**Marbach Pump Station Improvements (Volume I) &
Mission Road Service Center Drainage (Volume II) (RFCSP)
Solicitation Number: CO-00533
Job No(s): 20-6001/21-2501**

**ADDENDUM 6
September 27, 2023**

ELECTRICAL RACK SUPPORT DETAIL
NOT TO SCALE

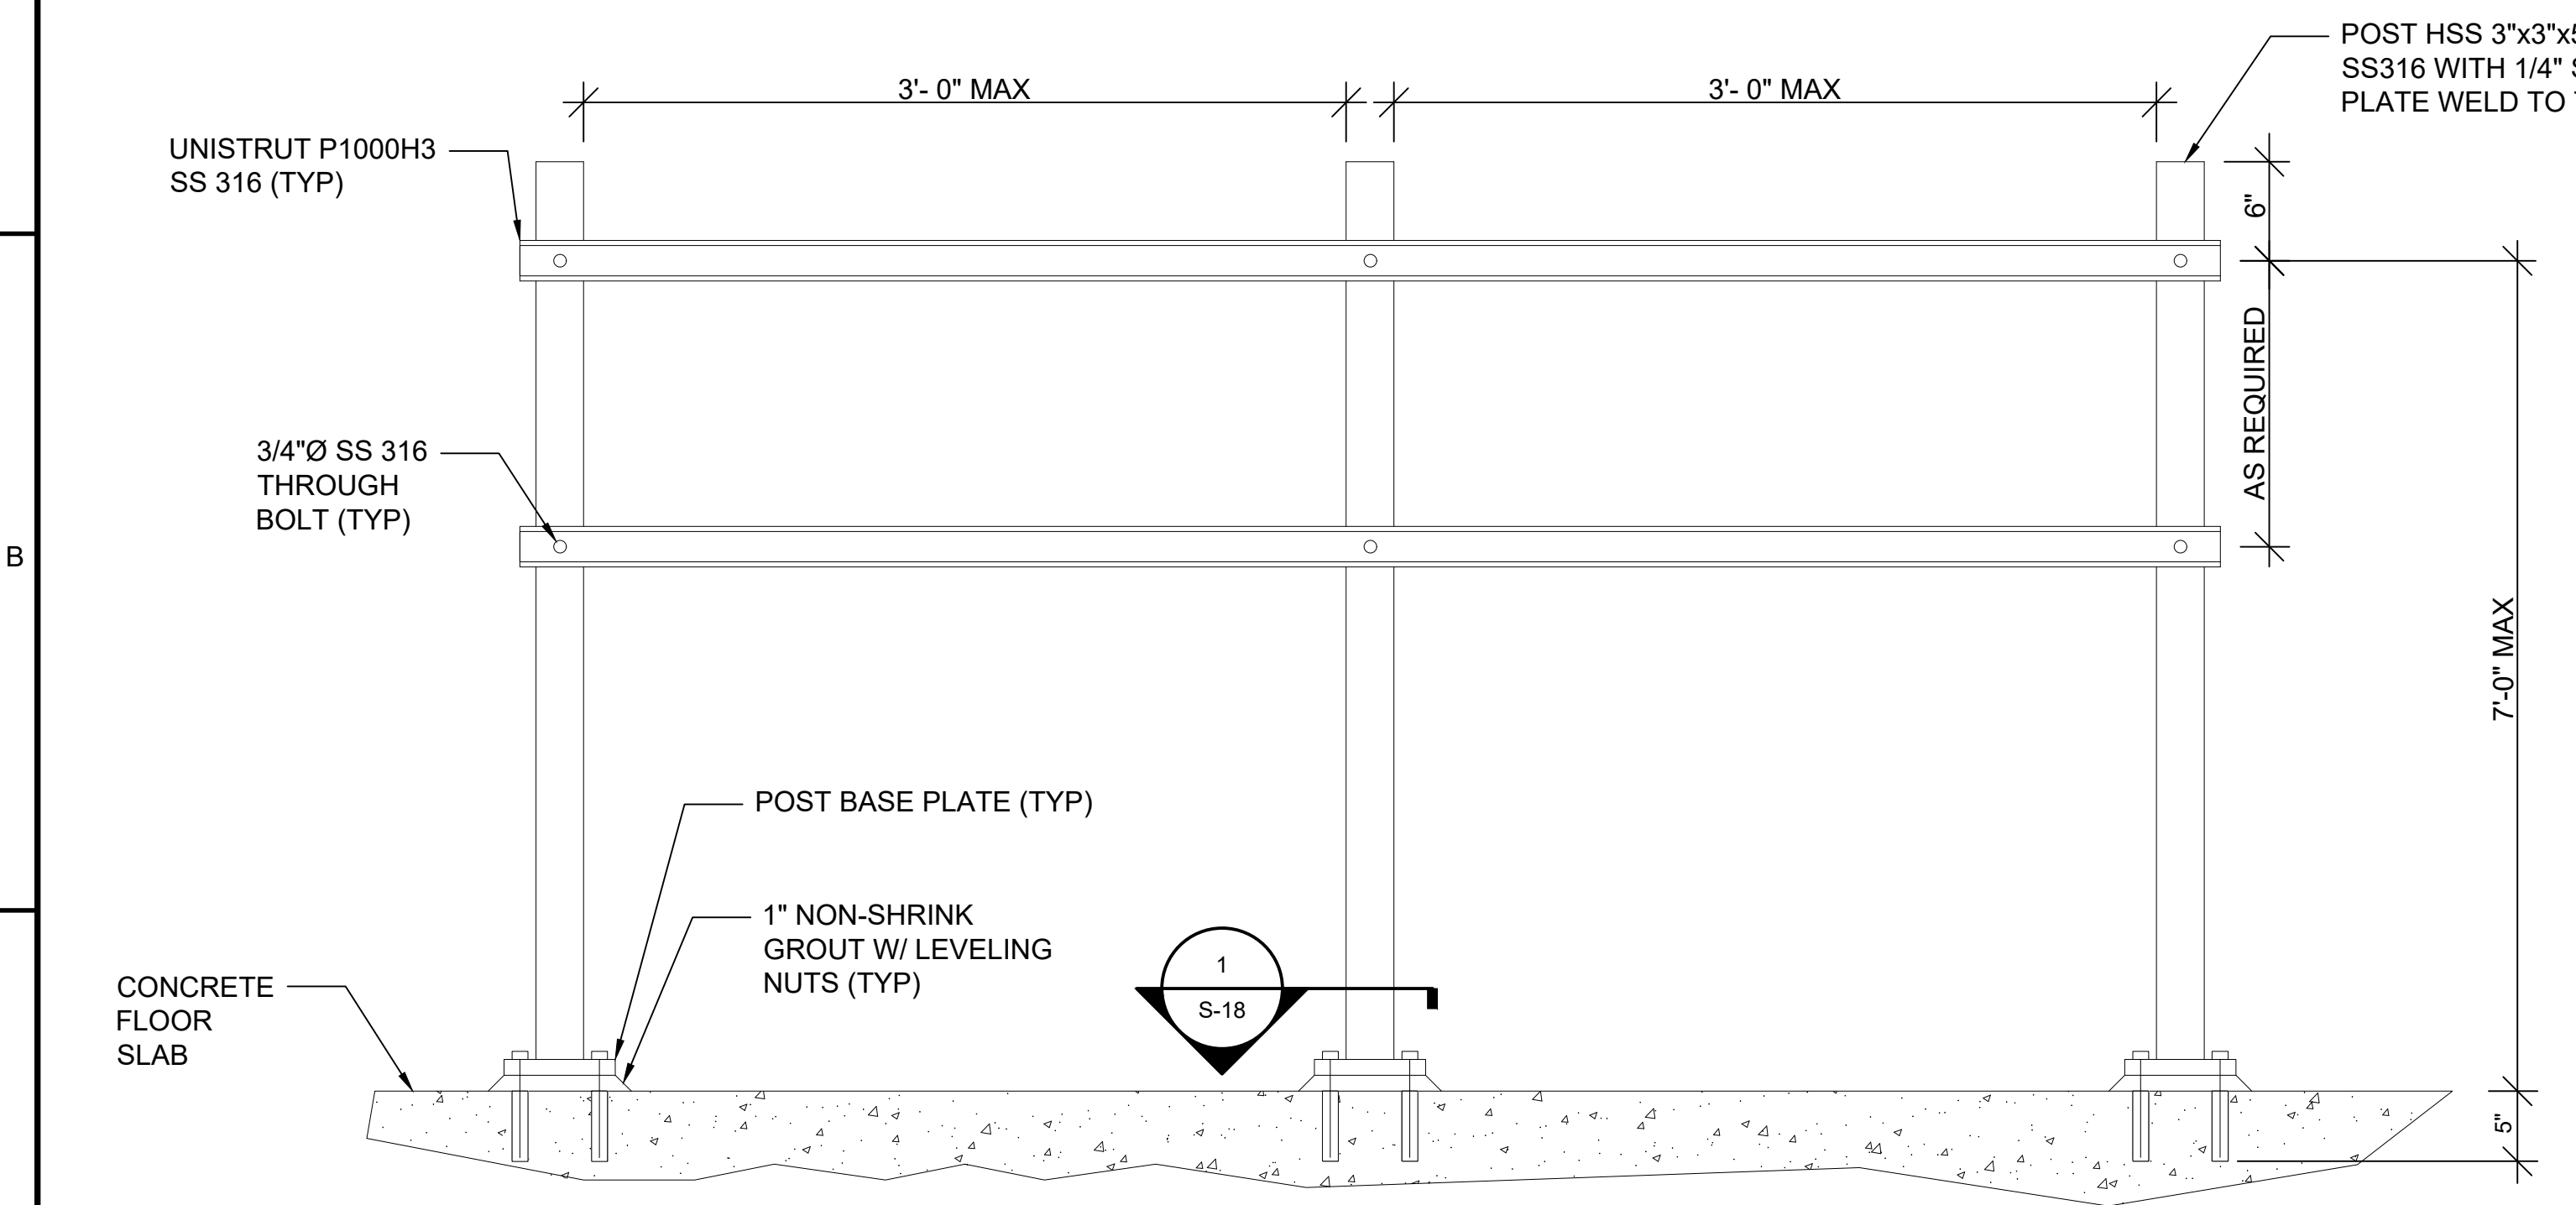
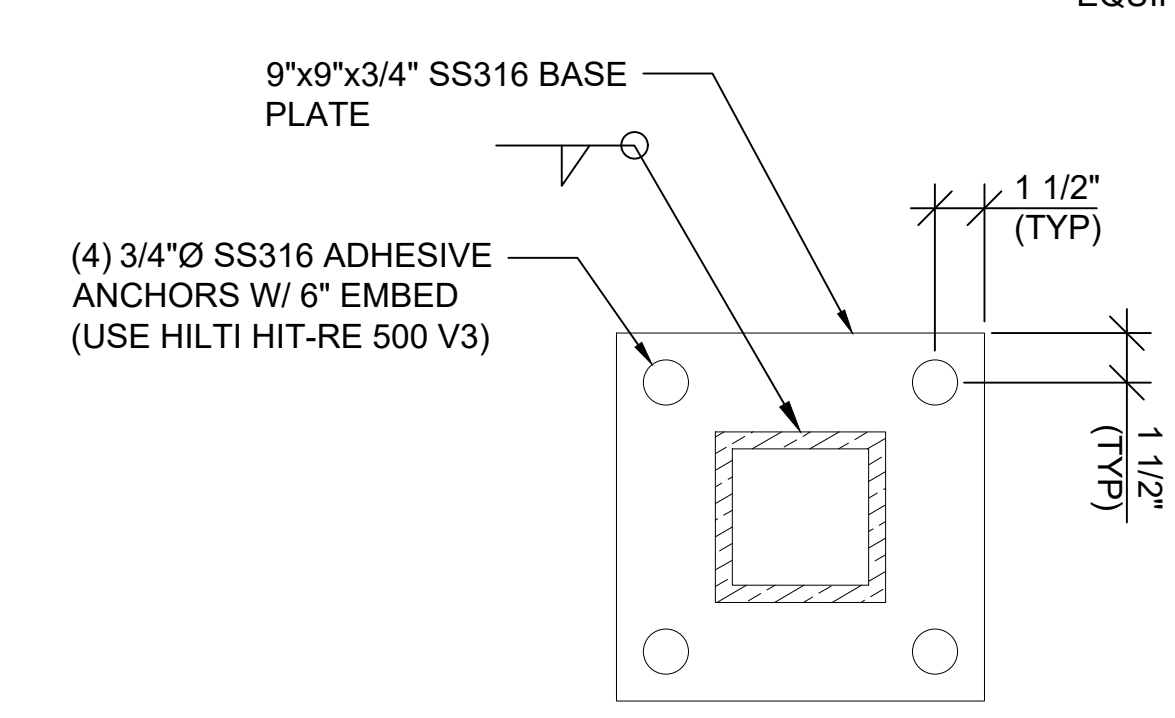
- 46. Question: Can a spec be provided for door canopies shown on the architectural elevations sheet A-07?**

Response: Additional information has been included in the plans. See Item Nos. 3, and 4 in the CHANGES TO THE PLANS section of this addendum.

PARTIAL ENLARGED
SITE PLAN
TEMPORARY POWER

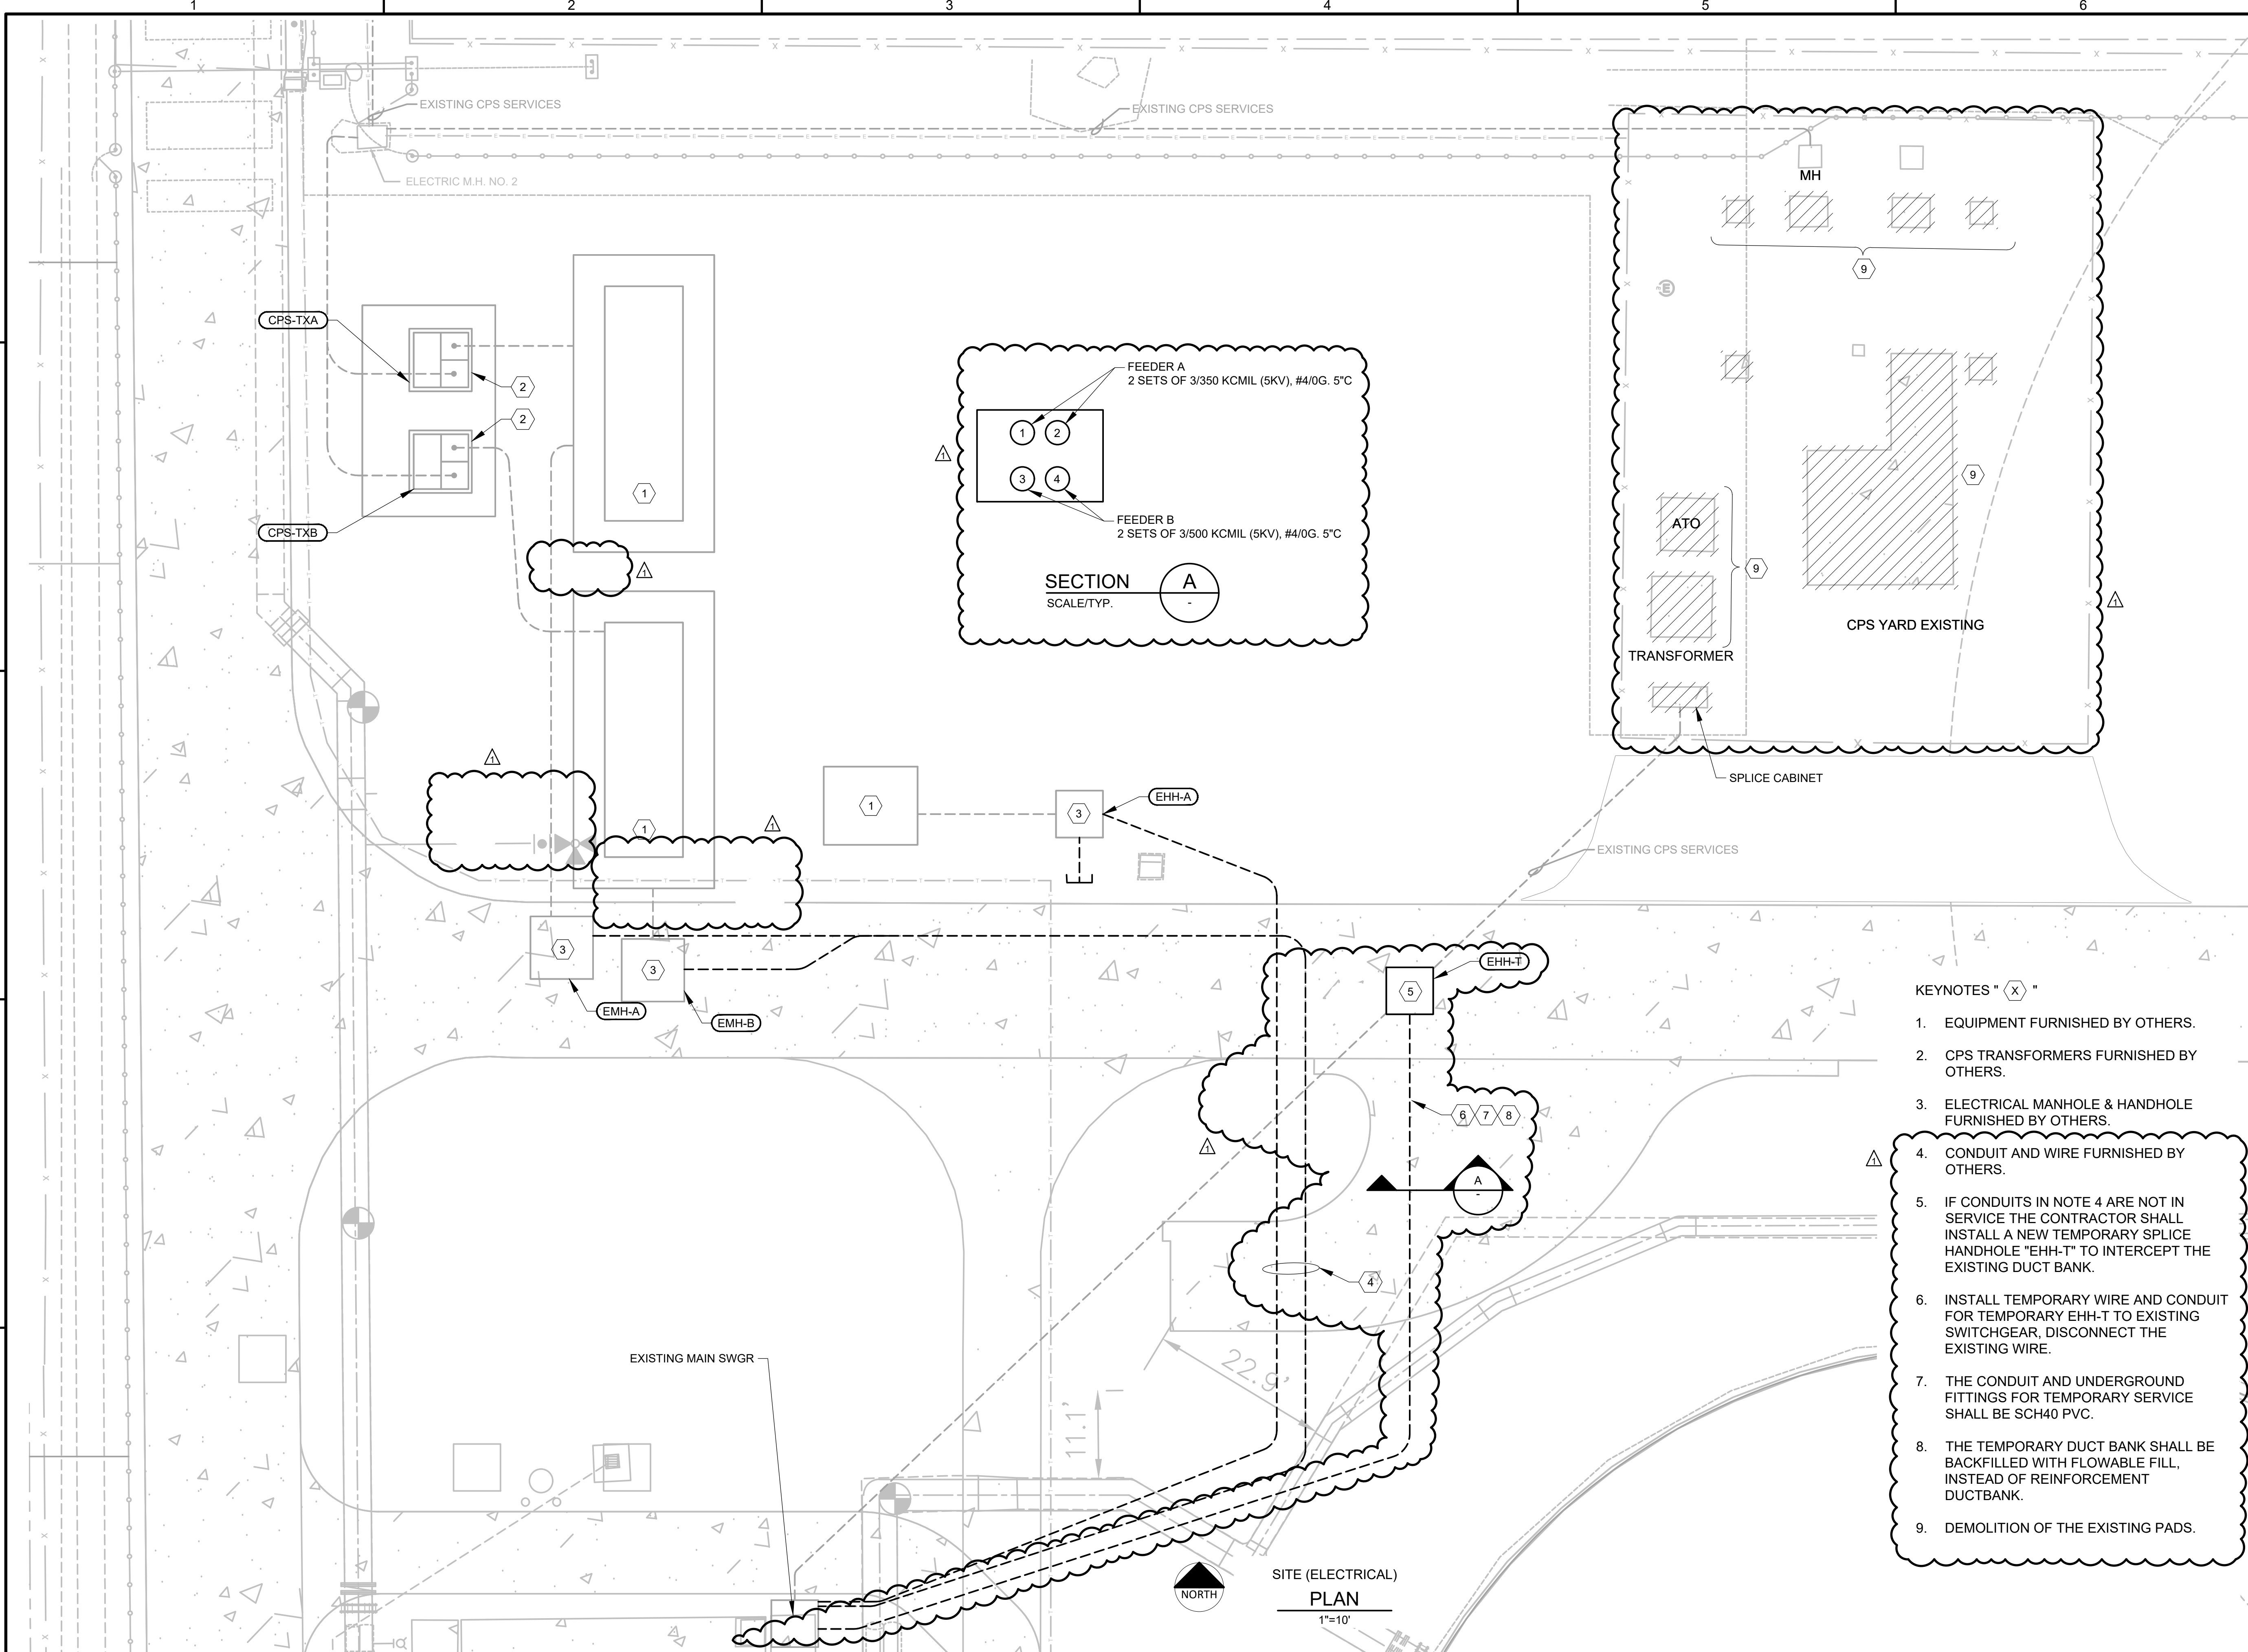
- 40. Question: We are requesting additional information be provided regarding Milestones or Key Dates for the referenced electrical equipment to be Provided by**

Others. Please reference electrical drawings E-4A, E-4B, E-4C, and EA-3. There are references in the drawings that the infrastructure associated with this equipment By Other is existing, however it was noticed during the Site Visit that none of the equipment, equipment pads, manholes, or duct banks were existing. According to layout drawing E-4C, it is assumed this equipment needs to be in place prior to work beginning on the New Electrical Building due to the re-feed of utility power to the existing Pump Station and required demolition of primary service duct bank from CPS Yard to Main Switchgear Enclosure. Please provide dates to be incorporated into the Schedule for when this work will be complete and available for use of this Project. This should include: installation of (2) CPS transformers CPS-TXA & CPS-TXB, installation of duct banks from CPS pole to new CPS transformers, installation of equipment and equipment pad referenced by Key Note 10 on E-4C, installation of duct banks between transformers and referenced equipment, installation of manholes EMH-A, EMH-B, and EHH-A, and installation of duct banks between equipment and referenced manholes.

- 41. Question: Reference drawing E-4A, E-4B, and E-4C. Note the duct bank line indicated from CPS Energy Yard to the existing Pump Station. According to drawing E-4B, this duct bank appears to terminate on the West side of the road near the northernmost pump of the existing pump station. We believe this to be inaccurate as this duct bank would be the utility feeder and should terminate in the existing Medium Voltage Switchgear located East of the road (Main Switchgear Enclosure noted on E-4A). The actual location of this duct bank is important as it is scheduled for demolition due to construction of the New Electrical Building and can impact the schedule of construction as noted in the previous question above. Please provide further information regarding the routing of this existing duct bank if available, and/or provide measures Contractor should take to incorporate the potential impact of the actual location into the Schedule and regarding the previous question above.**

- 67. Question: Reference drawing E-4B and E-4C. Due to schedule constraints and need for temporary duct bank to be installed for temporary utility feeder, can manholes EMH-A, EMH-B and EHH-A be furnished and installed as a part of this project and not by others in reference to Keynote 3.**

Response: The ductbank and manholes will be installed by a different contractor in the Other Project and will be available for the pump station contractor, it is anticipated that this work will be completed by July 2024. Please see response to Question No. 41 in this addendum. See Item Nos. 7, 8, and 13 in the CHANGES TO THE PLANS section of this addendum.

Response: On sheet E-4A, the incoming conduit from CPS yard should terminate in the existing switchgear, this conduit is correctly shown on sheet E-04, E-4A, E-4B and E-4C. It is true that this ductbank will interfere in the construction of the electrical building. Therefore, there are two solutions being provided:

- 1. It is anticipated that as part of the Other Project, the temporary ductbank and power will be available to the existing switchgear and hence the conduit from existing CPS yard will not be in service and therefore will not interfere in the construction of the new building.*
- 2. In case there is a delay in construction of the Other Project, the contractor shall intercept the existing incoming duct bank from CPS yard and reroute. See Item Nos. 7, 8, and 13 in the CHANGES TO THE PLANS section of this addendum. See item No. 1 in the CHANGES TO THE SPECIFICATIONS section in this Addendum.*
